Sundry Print Report

Well Name: Fuller 14/11 W1FC Fed Com	Well Location: T26S / R29E / SEC 14 / SWNE 1	County or Parish/State:
Well Number: 3H	Type of Well: CONVENTIONAL GAS WELL	Allottee or Tribe Name:
Lease Number: NMNM11038	Unit or CA Name:	Unit or CA Number:
US Well Number: 3001549326	Well Status: Approved Application for Permit to Drill	Operator: MEWBOURNE OIL COMPANY

Notice of Intent

Procedure Description: Mewbourne Oil Company requests that the following changes be made to Fuller 14/11 W1FC Fed Com #3H well: 1. Well name change to Fuller 14/23 W1KN Fed Com #3H. 2. BHL change to 330' FSL & 2570' FWL in Sec 23, T26S, R29E 3. Changes to directional design plot & plan corresponding to BHL change are included in sundry attachments. 4. Changes to csg program & cmt program corresponding to BHL change are included in this sundry request on page 3 & 4.

Fuller 14/23 WTRN Fed Com #3H

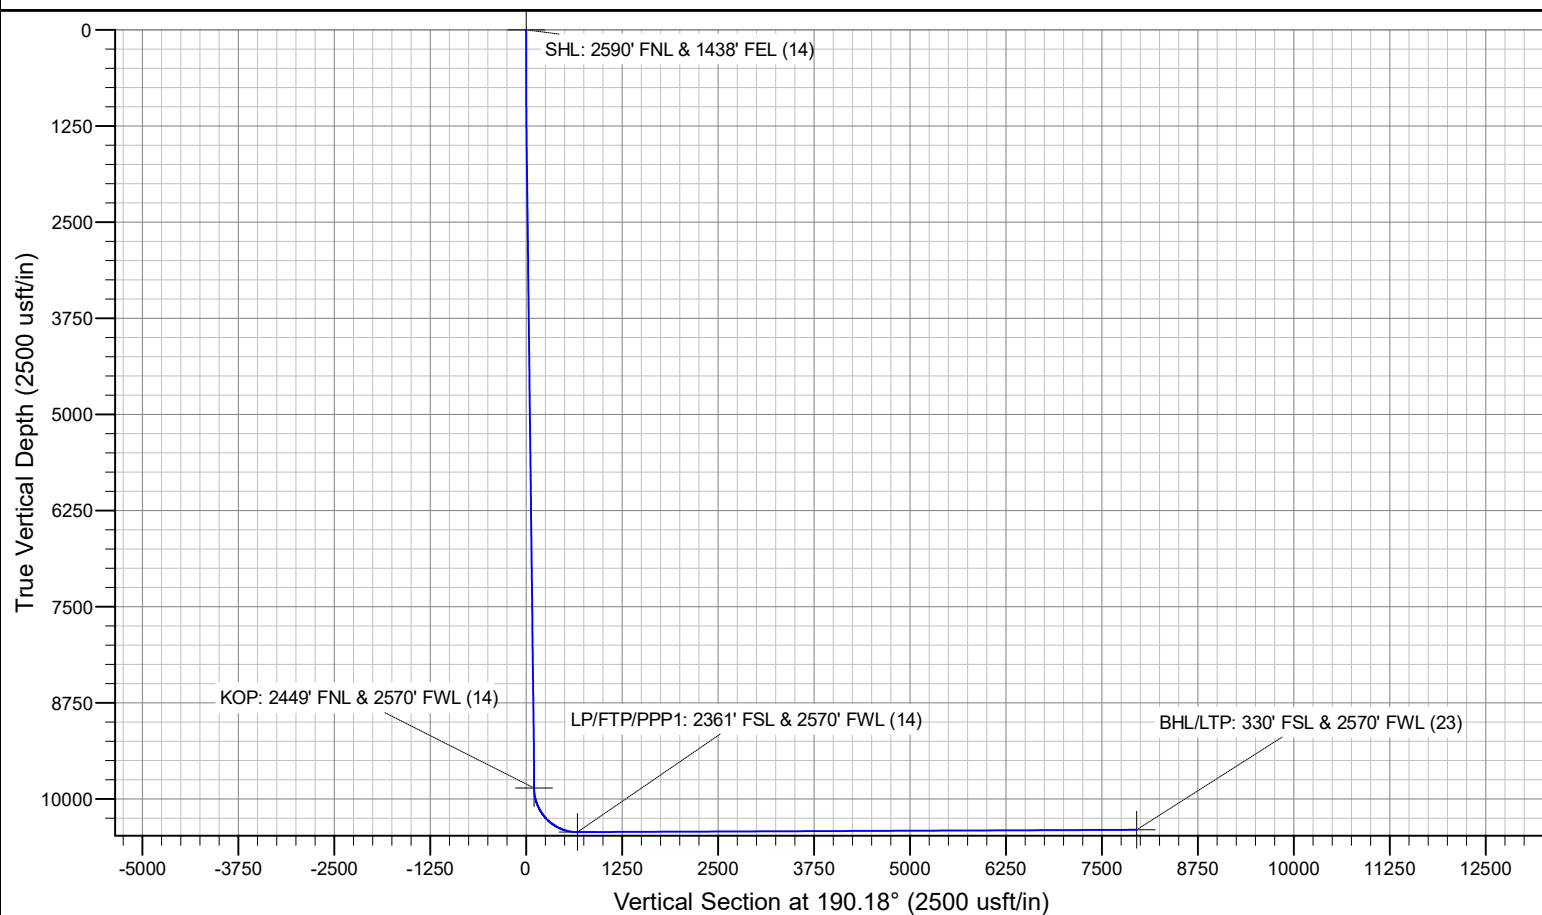
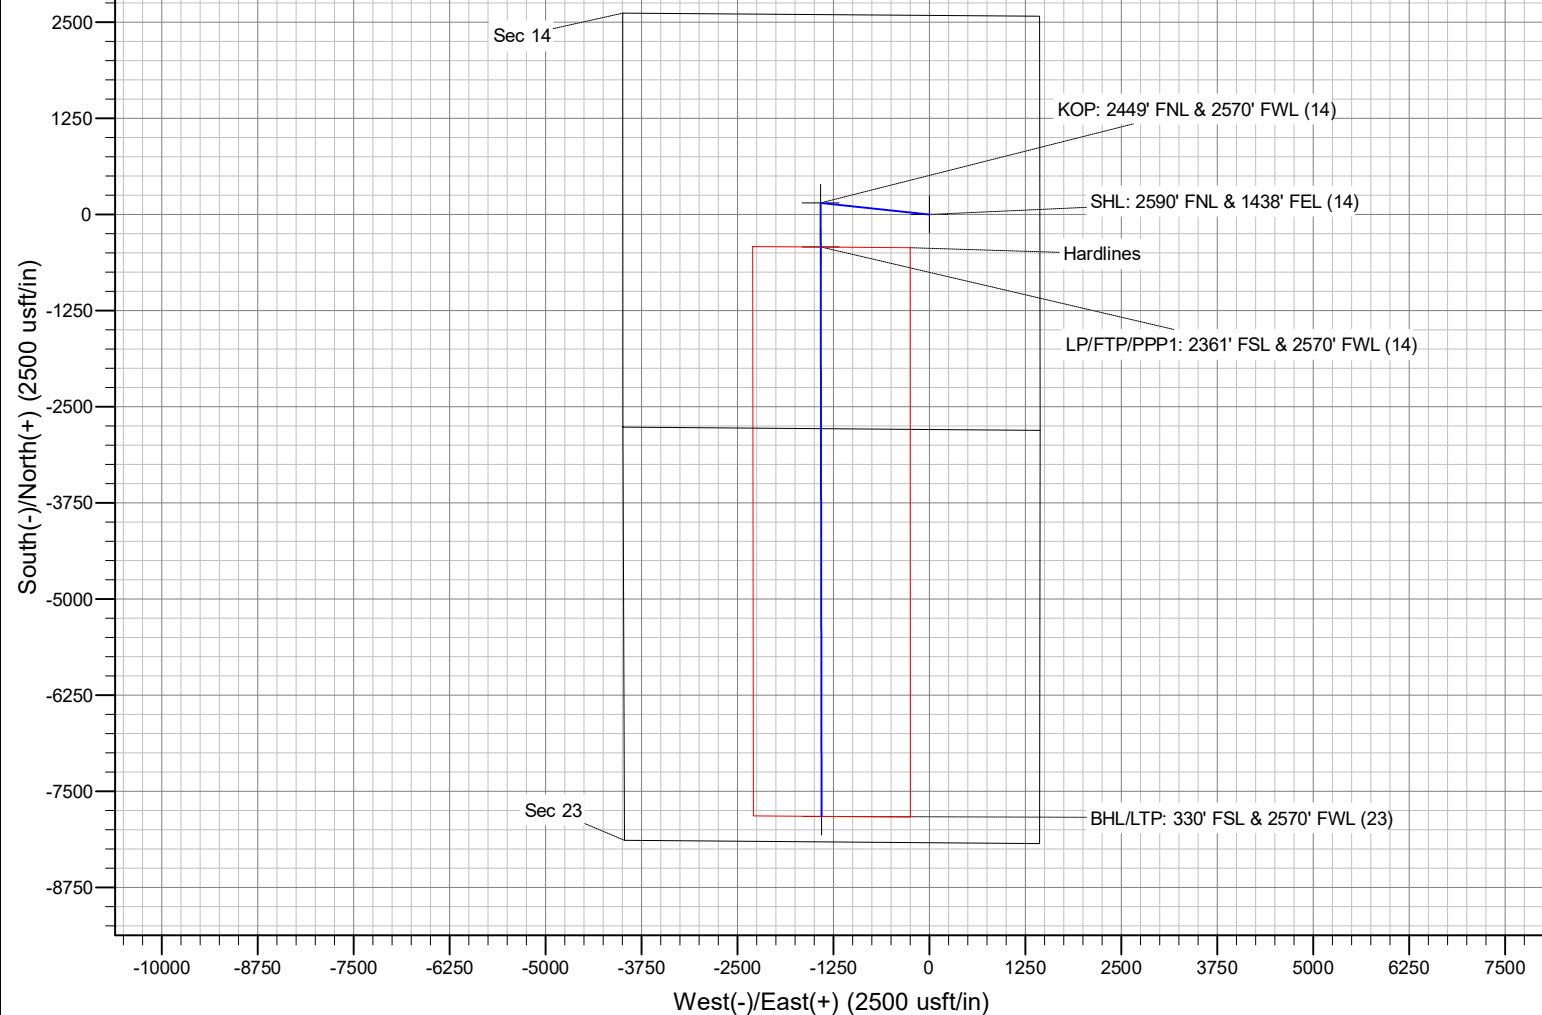
1. Well name change to Fuller 14/23 W1KN Fed Com #3H.
2. BHL change to 330' FSL & 2570' FWL in Sec 23, T26S, R29E
3. Changes to directional design plot & plan corresponding to BHL change are included in sundry attachments.
4. Changes to csg program & cmt program corresponding to BHL change are included in this sundry request on page 3 & 4.
